# HISTORIC AND DESIGN REVIEW COMMISSION

**HDRC CASE NO:** 2023-104  
**ADDRESS:** 312 RIDDLE ST  
**LEGAL DESCRIPTION:** NCB 729 BLK 3 LOT NE 46.3 FT OF 1, 2, 3 OR A3  
**ZONING:** R-6, H  
**CITY COUNCIL DIST.:** 1  
**DISTRICT:** Lavaca Historic District  
**APPLICANT:** ADRIANA ZIGA/ZIGA ARCHITECTURE STUDIO, PLLC  
**OWNER:** MONROY RICHARD  
**TYPE OF WORK:** Exterior modifications, porch column replacement, window replacement, fenestration modifications, site work, construction of a rear porch, construction of a rear accessory structure  
**APPLICATION RECEIVED:** March 17, 2023  
**60-DAY REVIEW:** Not applicable due to City Council Emergency Orders  
**CASE MANAGER:** Edward Hall  
**REQUEST:**

The applicant is requesting a Certificate of Appropriateness for approval to:

# 312 RIDDLE REHABILITATION

A200

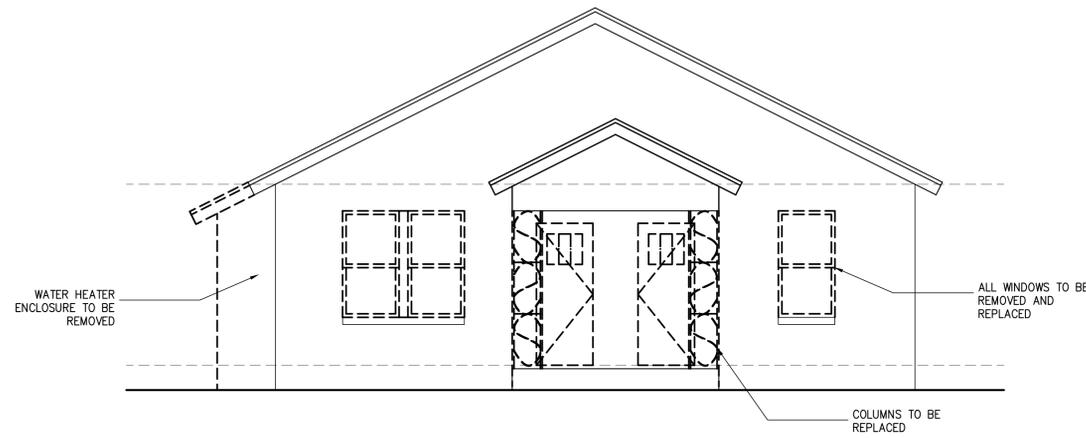
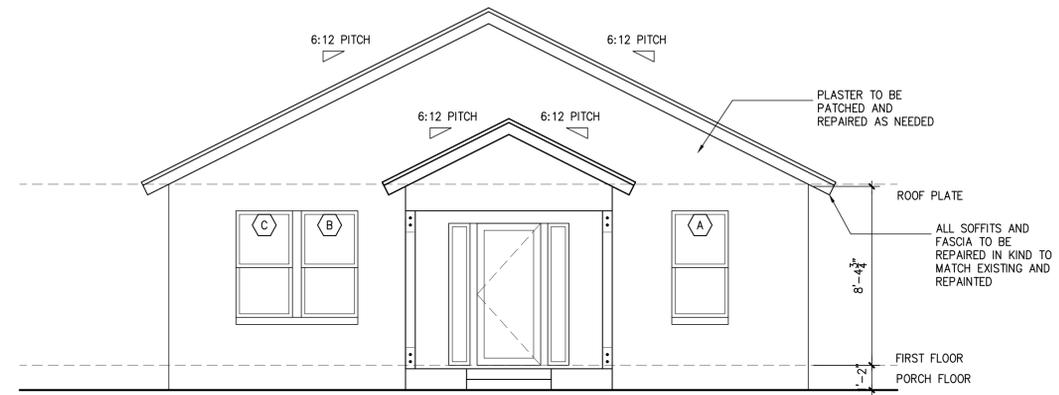
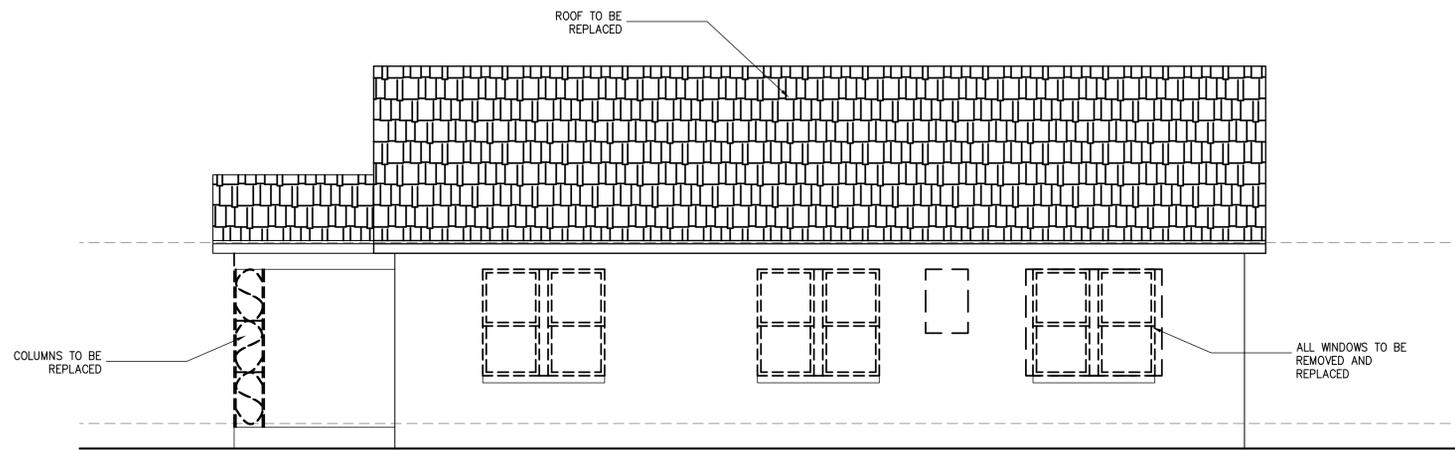
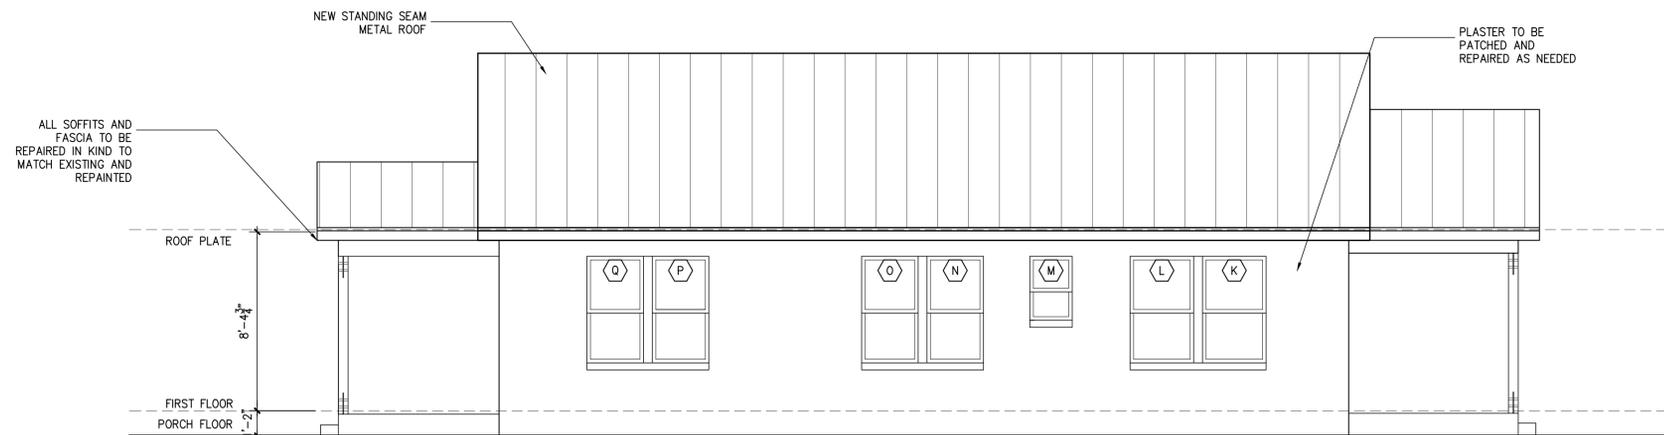
- f. FENESTRATION MODIFICATIONS (Front Façade) – The applicant has proposed fenestration modifications to the front façade that includes the removal of the existing two front doors and the creation of one, centered front door with two flanking side lites. Generally, staff finds the proposed modification to be appropriate; however, the applicant has proposed to install side lites in profiles that are inconsistent with the historic examples found within the district. Generally, side lites are only found when accompanied by a transom window. Additionally, side lites do feature one pane of glass that spans the entire height of the adjacent door. Staff finds that the proposed side lites should either be eliminated or should be proposed in a manner that relates to historic examples found within the district.

- g. FENESTRATION MODIFICATIONS (West Façade) – The applicant has proposed to install one, one over one window on the west façade. Generally, staff finds this modification to be appropriate and in keeping with the historic window profiles found on this house and within the district. The proposed window should match the existing in installation depth and profile.

- i. That the proposed front door feature side lites that are proposed in a manner that is consistent with historic side lites found within the district, as noted in finding e.

- ii. That all proposed windows match the original in profile and installation depth.
5. Staff recommends approval of item #5, the installation of a driveway apron, ribbon strip driveway and rear parking pad based on finding j with the following stipulation:

A201

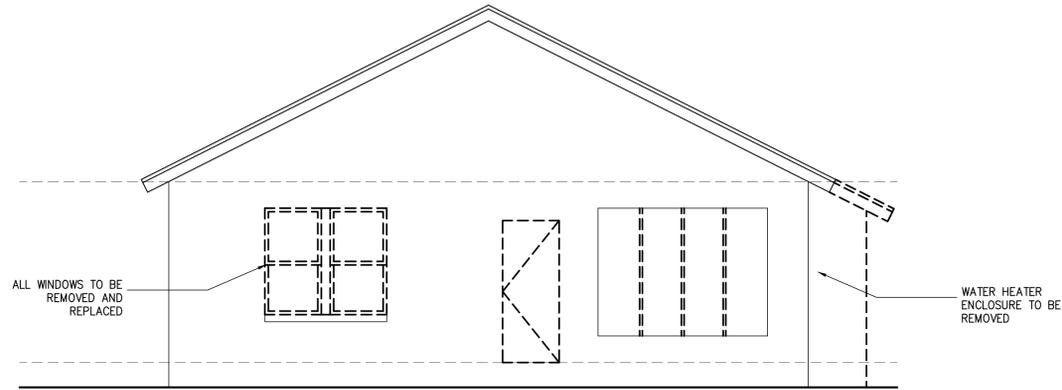
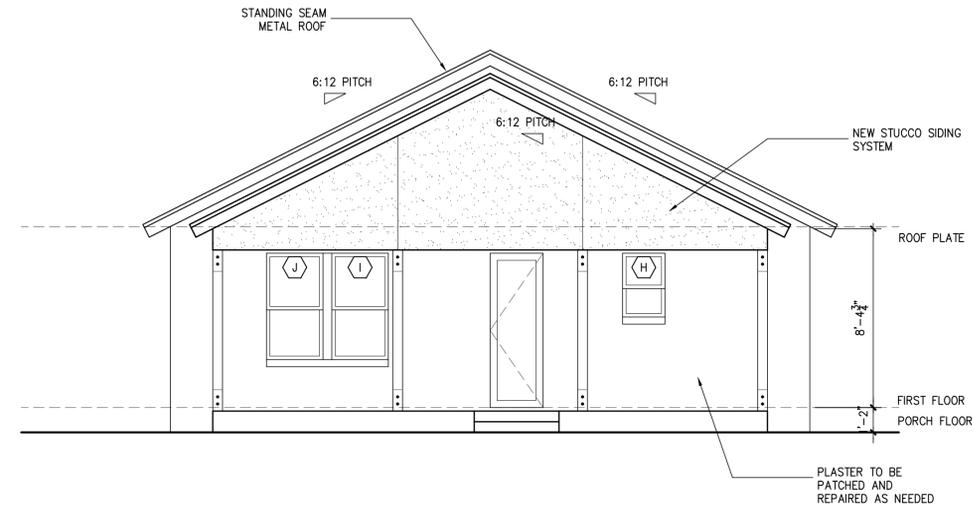
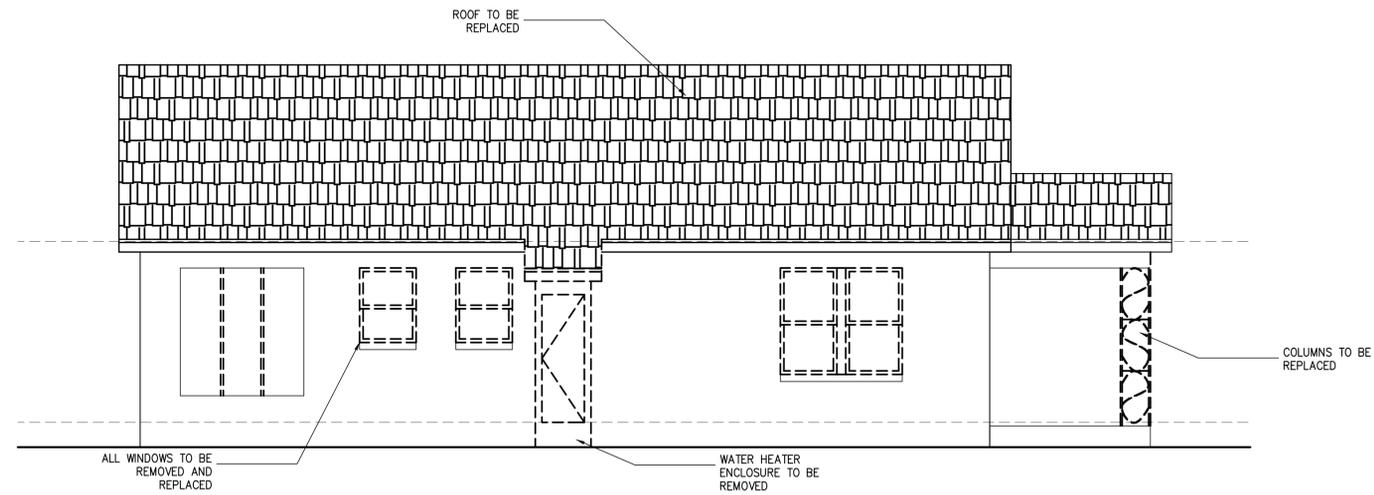
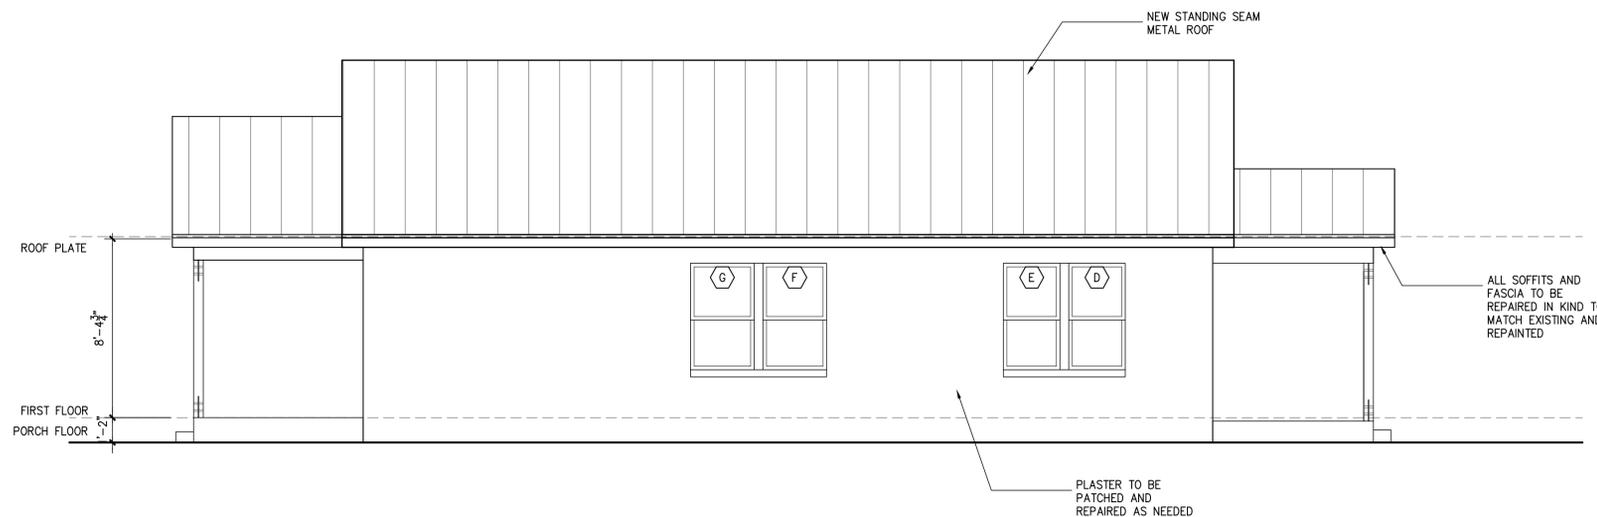
- h. FENESTRATION MODIFICATIONS (East Façade) – The applicant has proposed to remove two, single window openings and create a grouped window opening to match the existing grouped window opening on this façade. An existing wall opening towards the rear of the façade will be enclosed and a water heater closet addition will be removed. Staff finds the proposed modifications to be appropriate. The proposed windows should match the existing in installation depth and profile.

- i. FENESTRATION MODIFICATIONS (Rear Façade) – The applicant has proposed to install one new one over one window on the rear façade. Additionally, an existing façade opening at the rear of the structure will be enclosed. Generally, staff finds the proposed fenestration modifications to be appropriate. The proposed windows should match the existing in installation depth and profile.

**1** TYPICAL COLUMN DETAIL

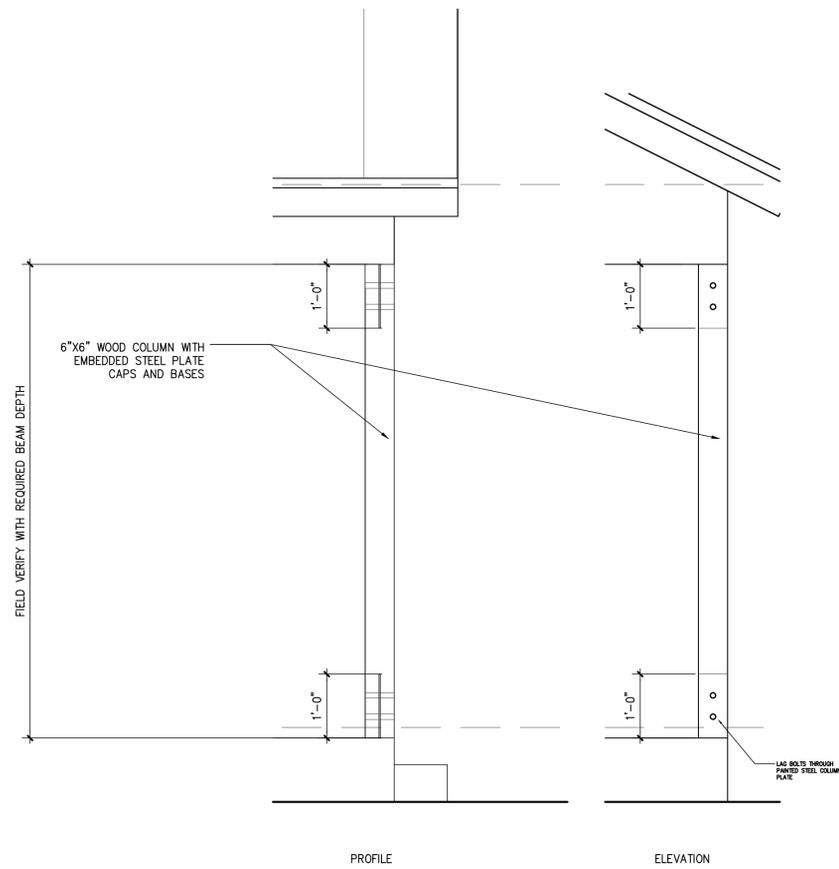
- PORCH REPLACEMENT** – The applicant has proposed to replace the existing, concrete porch slab, in-kind, and to replace the existing wrought iron porch columns with wood porch columns. Generally, staff finds the proposed scope of work to be appropriate; however, staff finds that the proposed replacement columns should feature six (6) inches square with capital and base trim and chamfered corners. Column and porch work should adhere to the adopted policy guide for porches.

2. Staff recommends approval of item #2, porch repair and column replacement based on finding d with the following stipulation:
  - i. That the proposed replacement columns feature six (6) inches square with capital and base trim and chamfered corners. Column and porch work should adhere to the adopted policy guide for porches.

A200

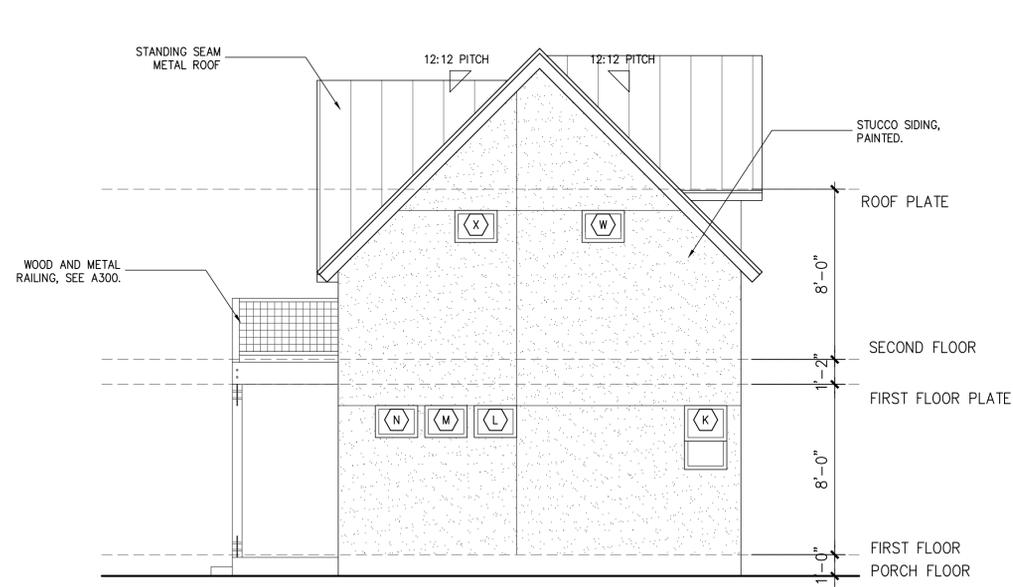
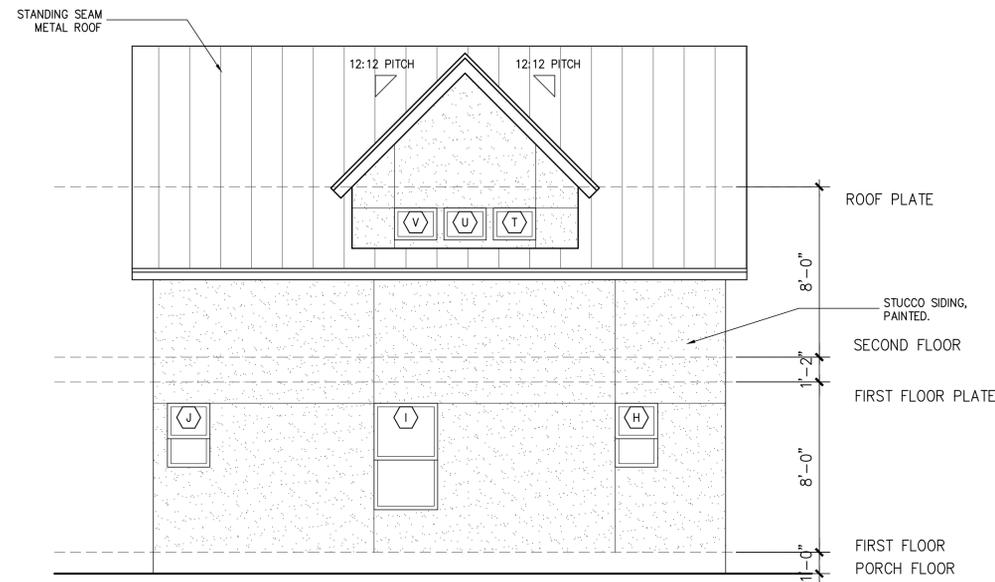
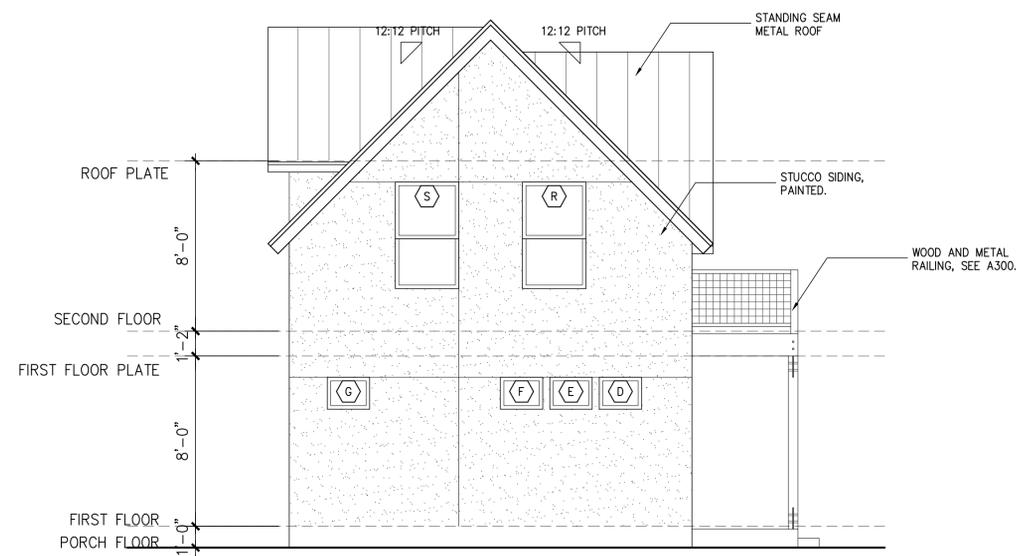
- n. NEW CONSTRUCTION (Materials) – The applicant has proposed materials that include stucco facades, a standing seam metal roof, wood and metal railings, and aluminum clad wood windows. Generally, staff finds the proposed materials to be appropriate and consistent with the Guidelines. Staff finds that the proposed stucco should have a finish that matches that of the primary historic structure on site. The proposed replacement roof should feature smooth panels that are 18 to 21 inches in width, seams that are 1 to 2 inches in height, and a crimped ridge seam. Staff finds the charcoal gray roofing color to be appropriate in place of the standard

- p. NEW CONSTRUCTION (Architectural Details) – Generally, staff finds the proposed new construction to be appropriate and consistent with the Guidelines; however, staff finds that all windows should feature profiles that are consistent with the historic window profiles found on site and within the district. Grouped windows should be separated by a mullion of six (6) inches in width. Square, fixed windows should be modified to feature profiles that are consistent with those found historically on site and within the district.

- i. That the proposed replacement roof feature smooth panels that are 18 to 21 inches in width, seams that are 1 to 2 inches in height, and a crimped ridge seam. A low profile ridge cap or ridge sleeve is appropriate for new construction. The roofing panels shall not feature corrugation or striations and a material inspection will be required prior to installation. The proposed charcoal gray color is appropriate.

- ii. That all windows feature profiles that are consistent with the historic window profiles found on site and within the district. Grouped windows are to be separated by a mullion of six (6) inches in width. Square, fixed windows should be modified to feature profiles that are consistent with those found historically on site and within the district.

**1 TYPICAL WALL SECTION**

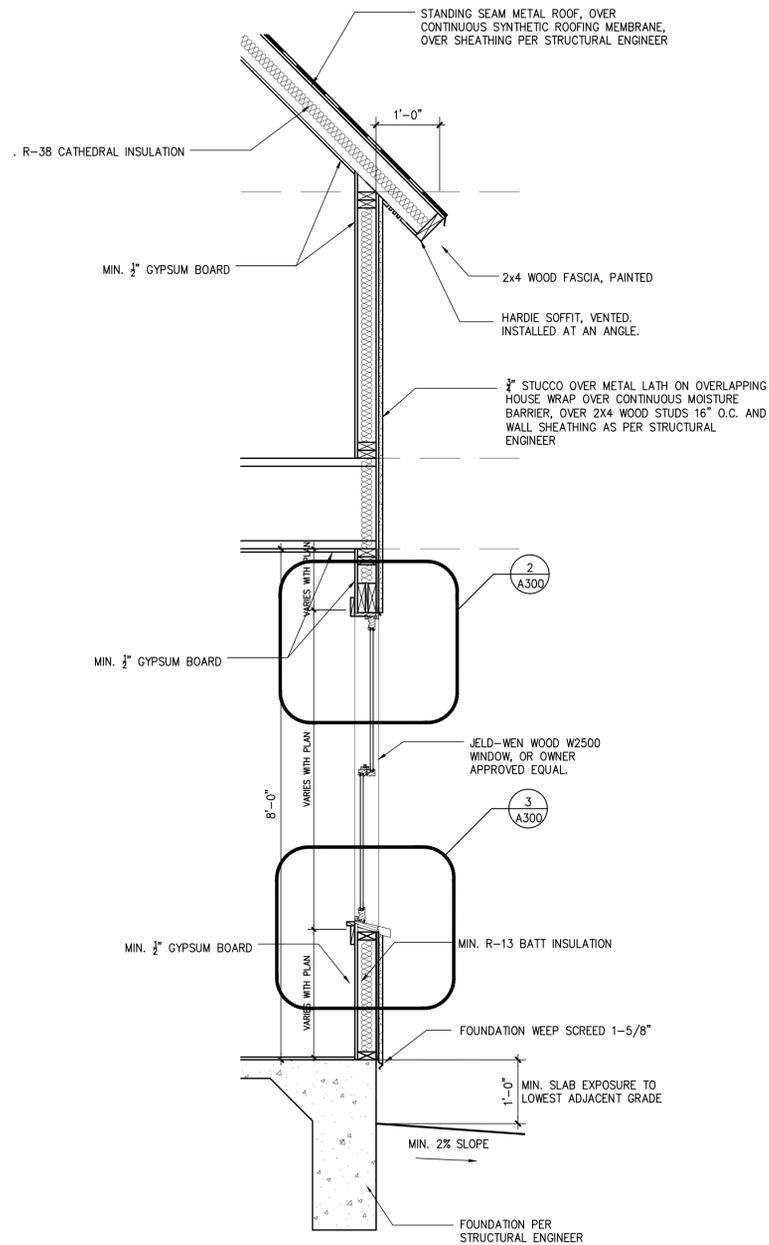
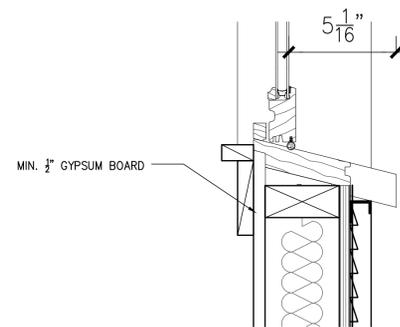
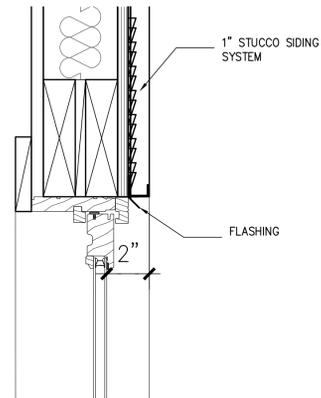
- o. NEW CONSTRUCTION (Window Materials) – The applicant has proposed aluminum clad wood windows and has provided a wall section noting the proposed installation depth and profile. Generally, staff finds the proposed windows to be appropriate and consistent with the adopted policy guide for windows.
